January 25, 2021  
**VIA E-MAIL**

Re: ***375 Main Street – Site Plan Approval  
Section 108.03, Block 1, Lot 75***

As you know, we represent NY Fuel Distributors, LLC (the “Applicant”) in connection with the above-referenced property (the “Subject Property”). We respectfully submit herewith the following amended plans and supplemental information for your consideration at your upcoming meeting on February 8, 2021.

PROJECT:  
**PROPOSED SITE IMPROVEMENTS TO SHELL GAS STATION**  
 375 MAIN STREET  
 ARMONK, NY

**PROPOSED LIGHTING PLAN**  
 SCALE: 1" = 10 FEET

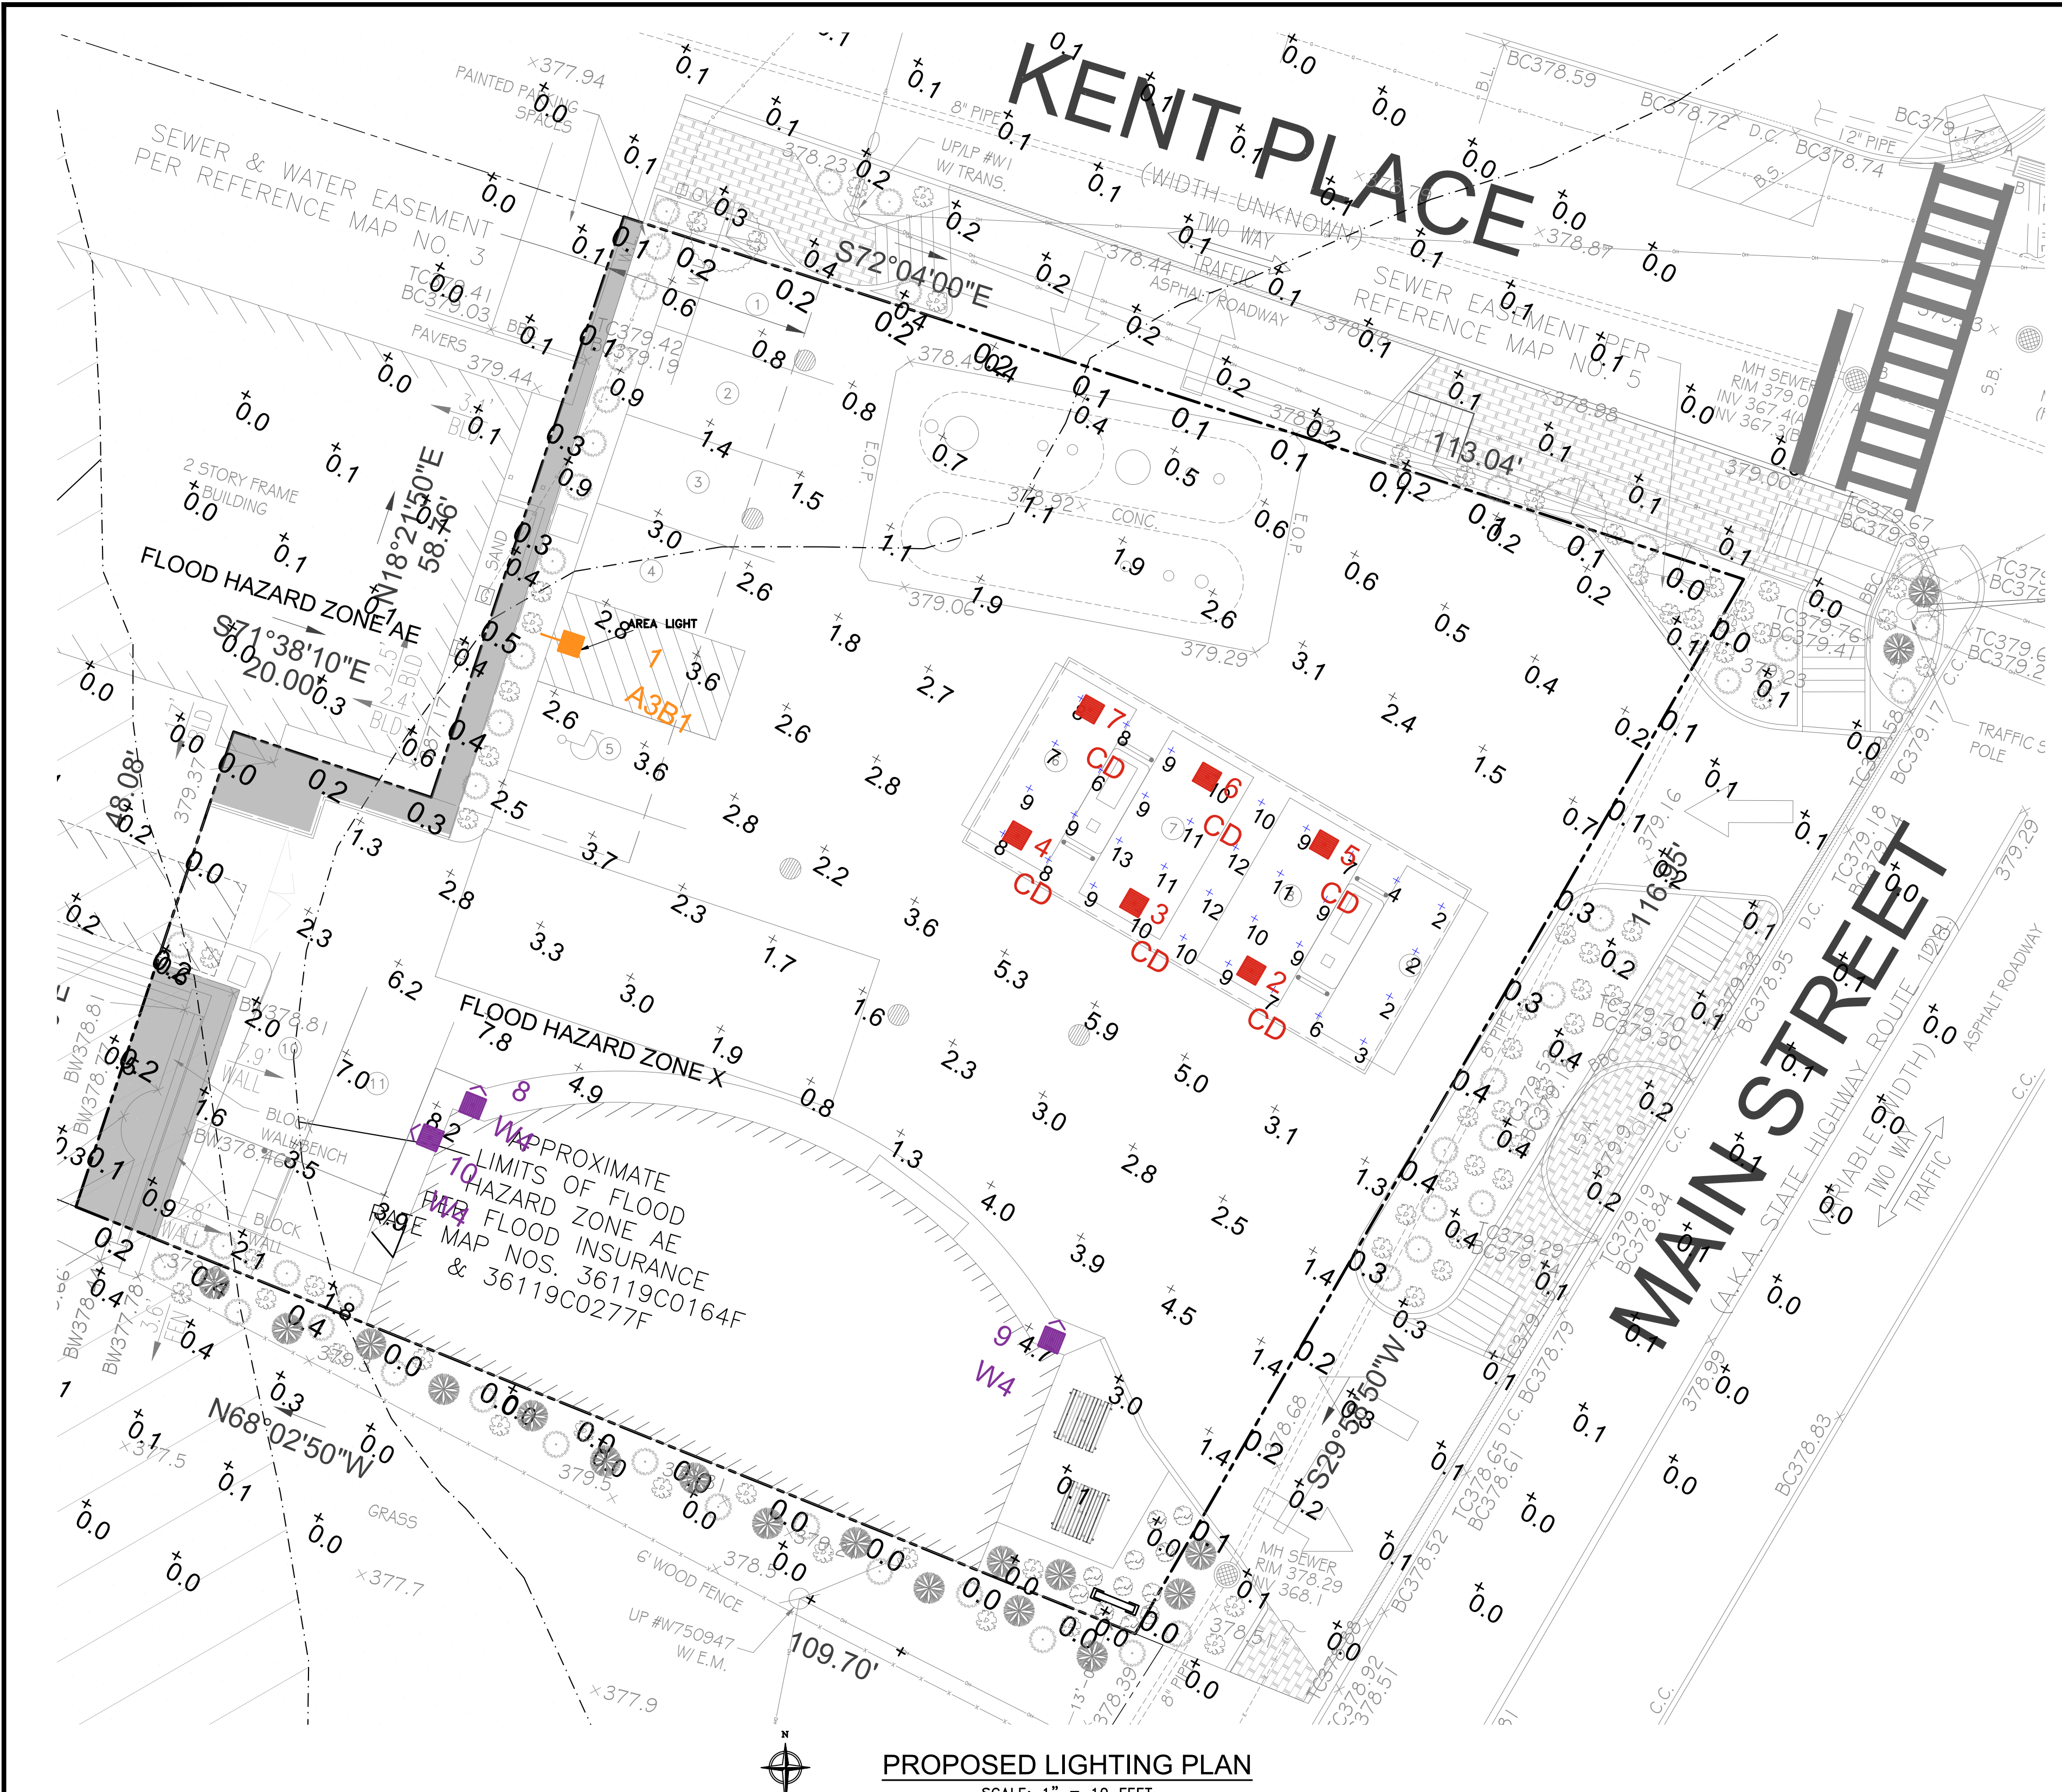
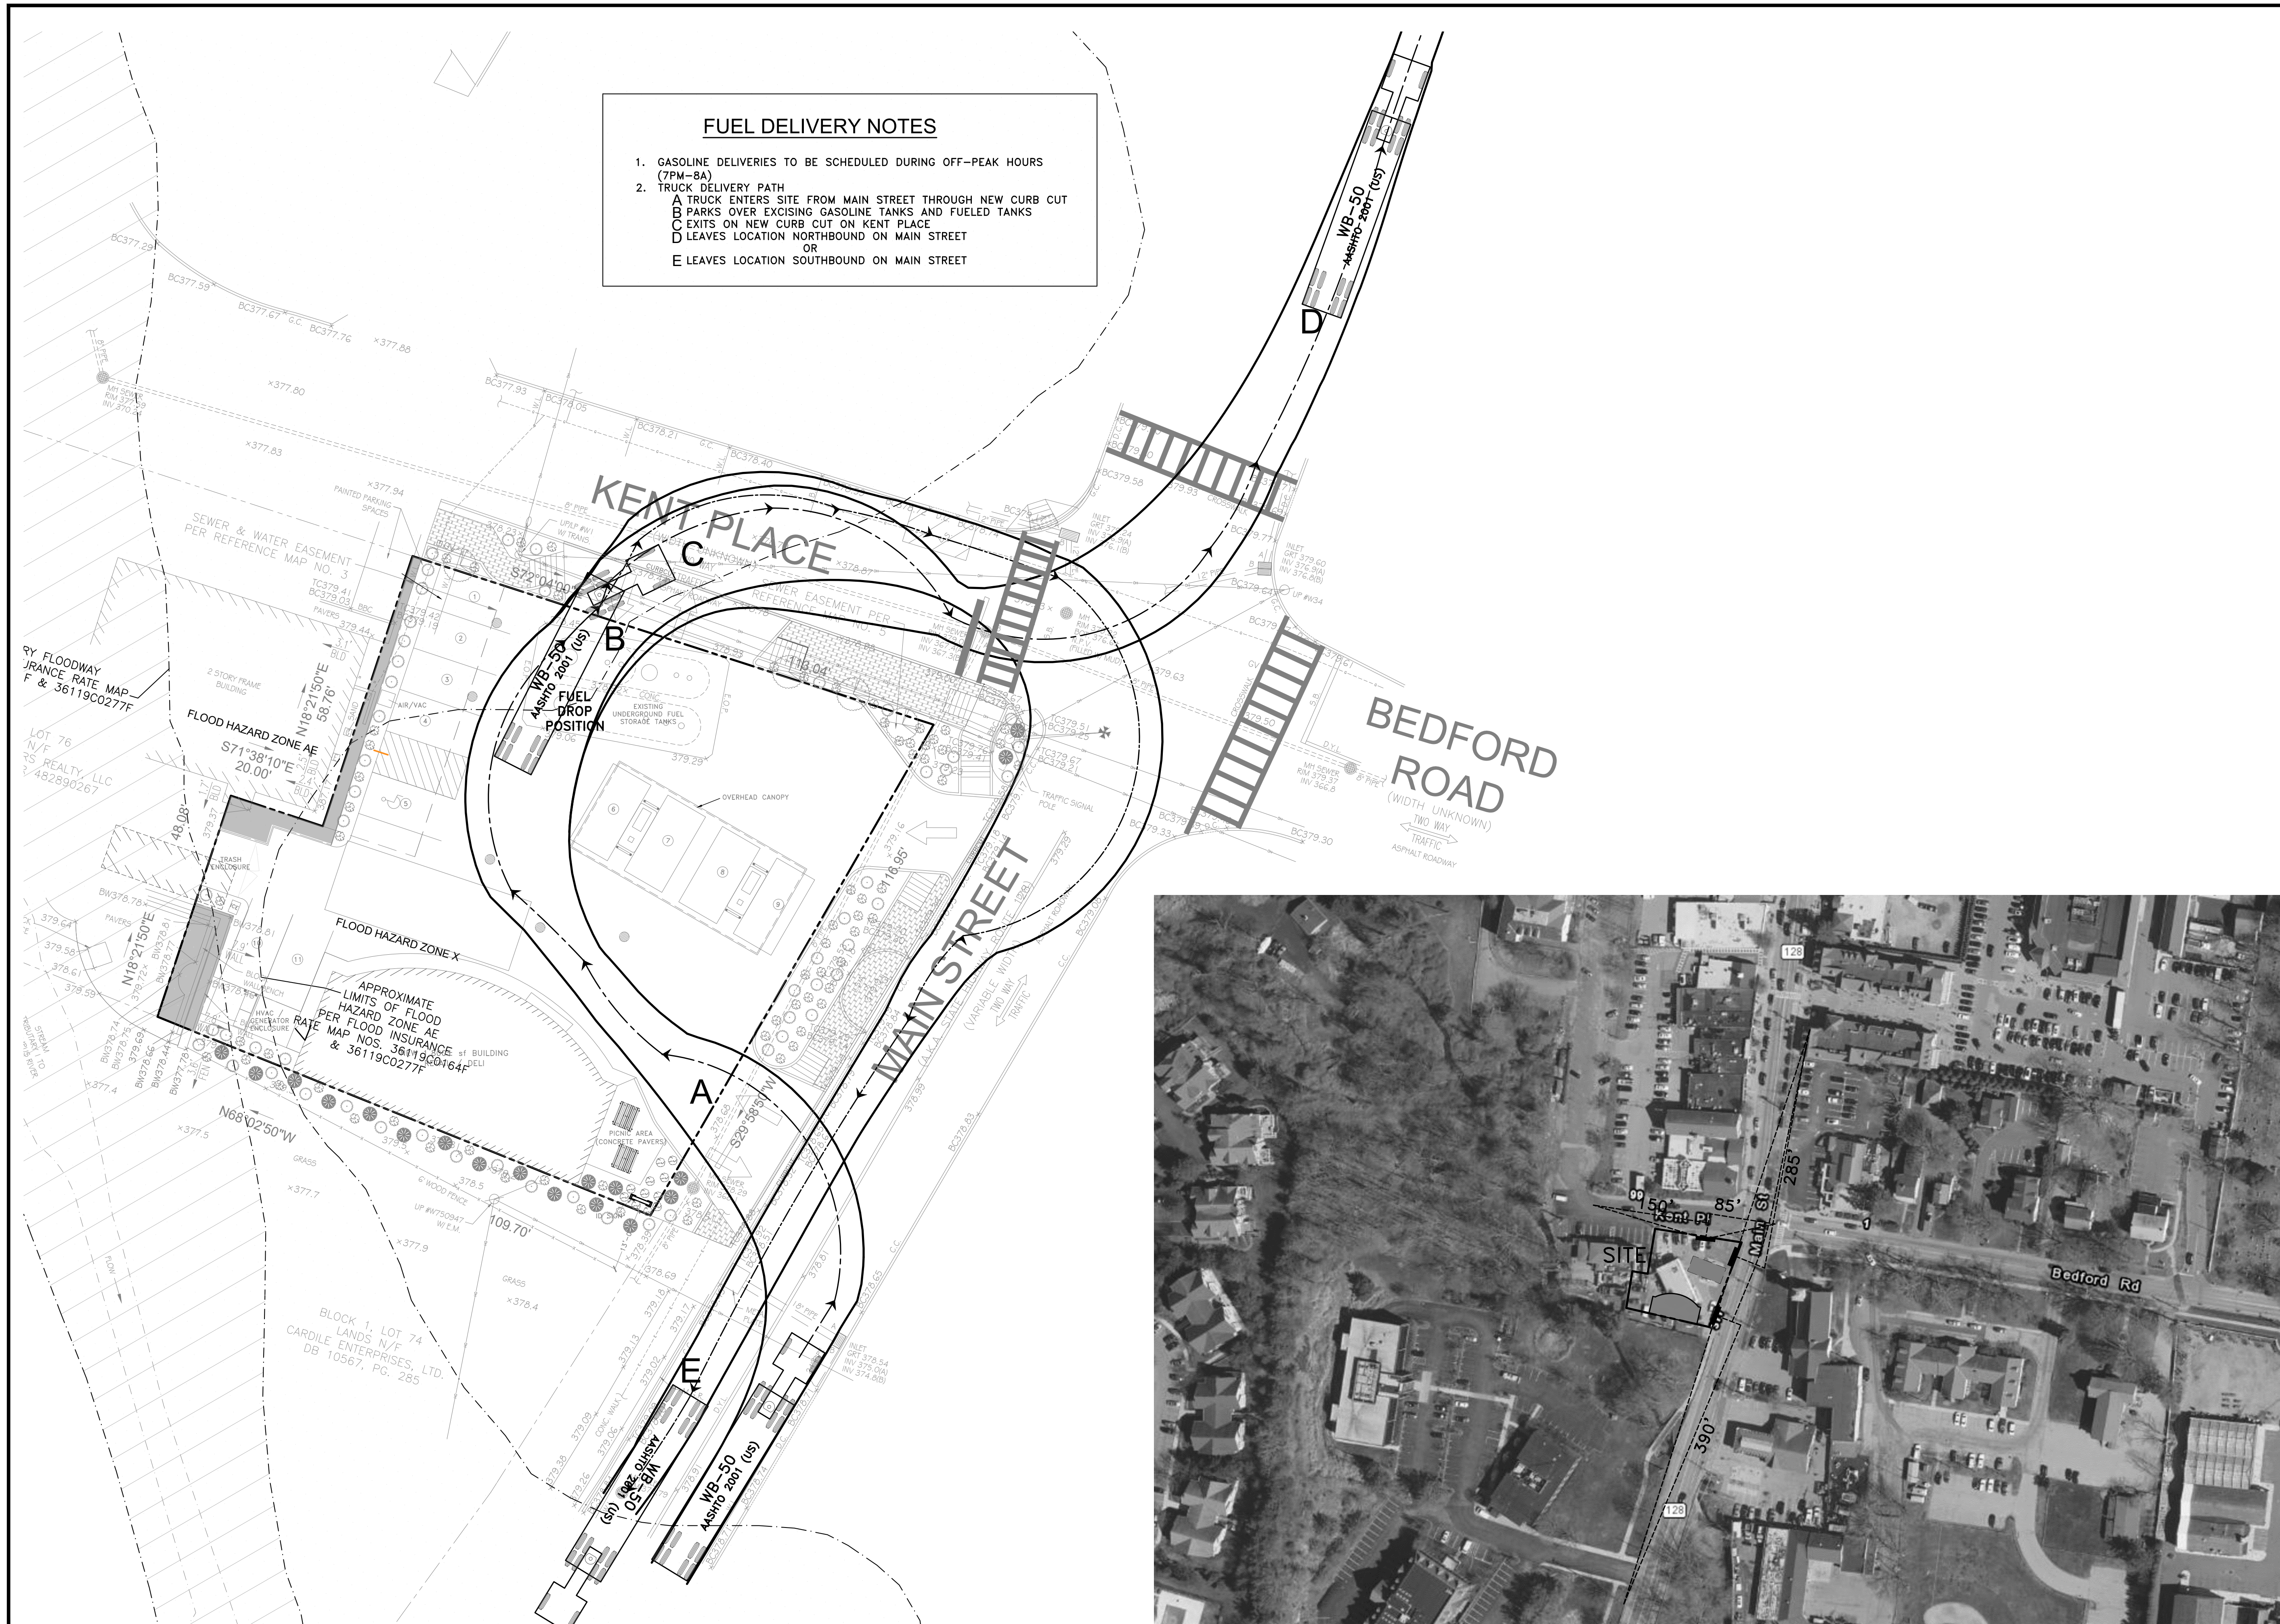
- a. The requested sight line profiles have been added to Sheet C-007.00.
14. *As requested, the applicant has provided an updated lighting plan demonstrating reduction in light level. The applicant shall note the hours of operations on the lighting plan.*

- a. The station is proposed to operate 24 hours a day and a note has been added to the lighting plan.

**PROPOSED ID SIGN ELEVATIONS (34.29 sf)**  
 SCALE: 1/2" = 1'-0"

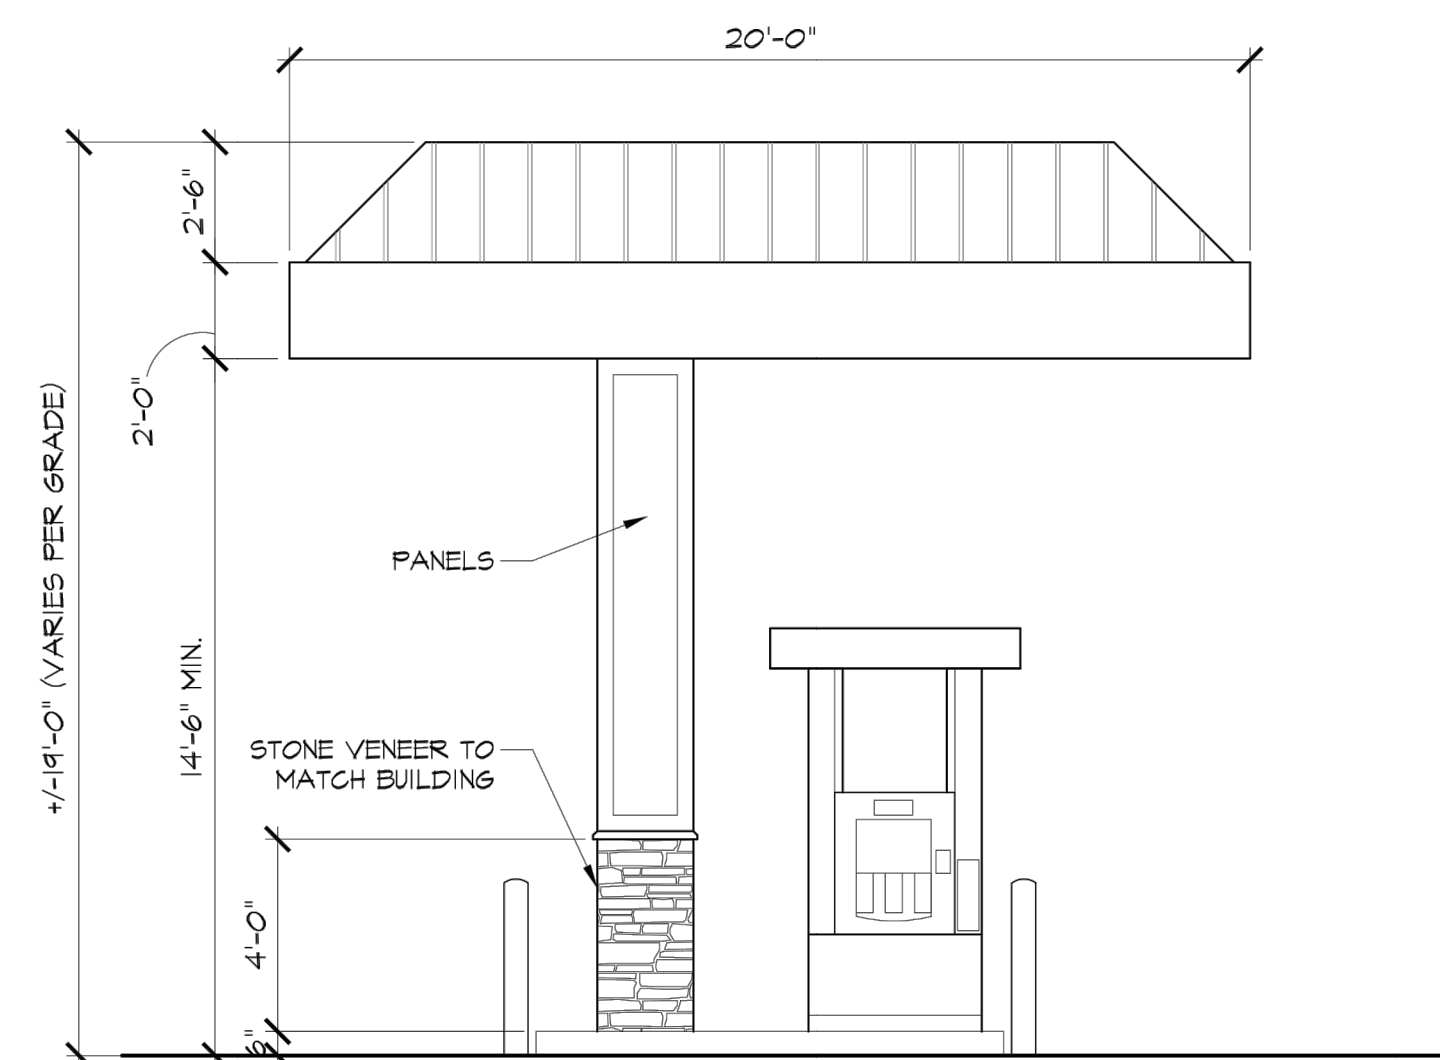
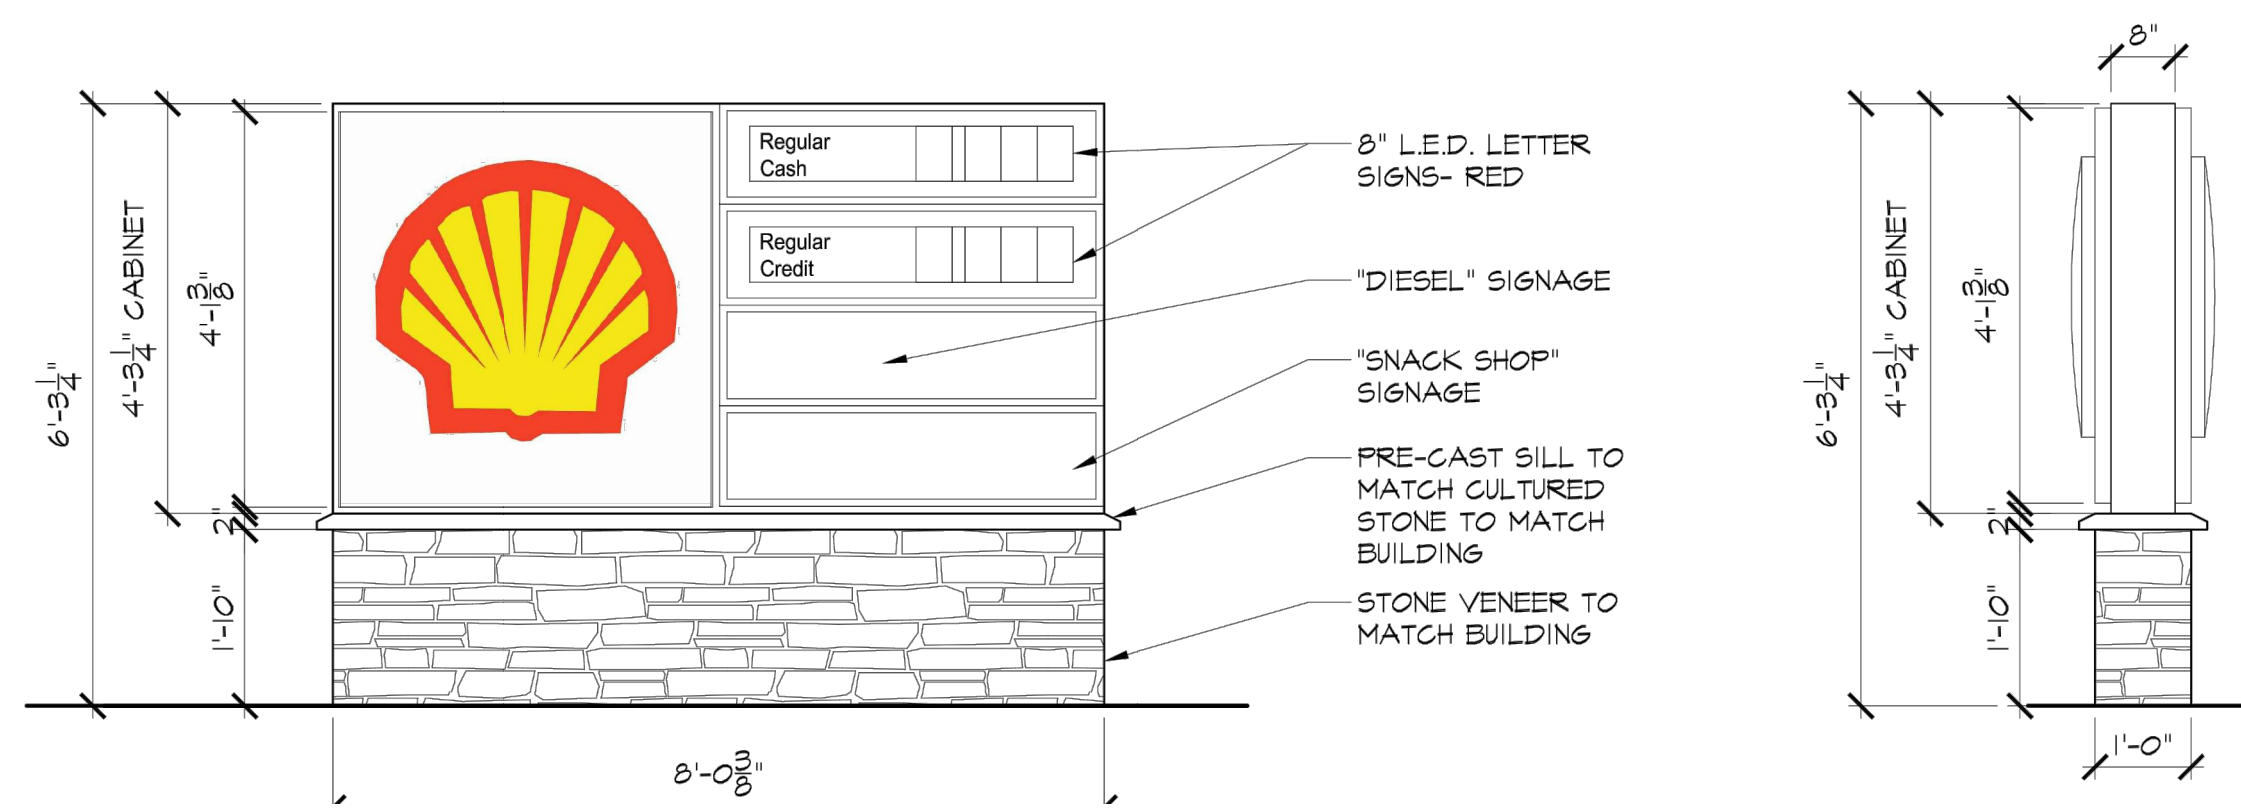
12. *The site plan depicts the proposed canopy no closer than 8 feet to Main Street. The Building Department should confirm that the proposed encroachment is permitted.*

18. *The site plan should be revised to depict all proposed signage – free standing, building mounted and others. The Applicant should submit an exhibit depicting conformance with Section 355-16 of the Town Code.*

- a. The Applicant confirmed the canopy encroachment was permitted with the Building Inspector in June 2020. The Building Inspector will follow the determination of the Zoning Board of Appeals from October 1989 concerning Gas Station Canopies. A copy of the minutes from that meeting and a memo to the Planning Board concerning the same are submitted herewith.

- a. All proposed signage is depicted on the architectural elevations included in the site plan package. The building mounted signage is limited to the front and rear of the building and will comply with the Town Code. The proposed monument sign will require a variance as the sign is 34.29 square feet and the maximum permitted is 25.08 square
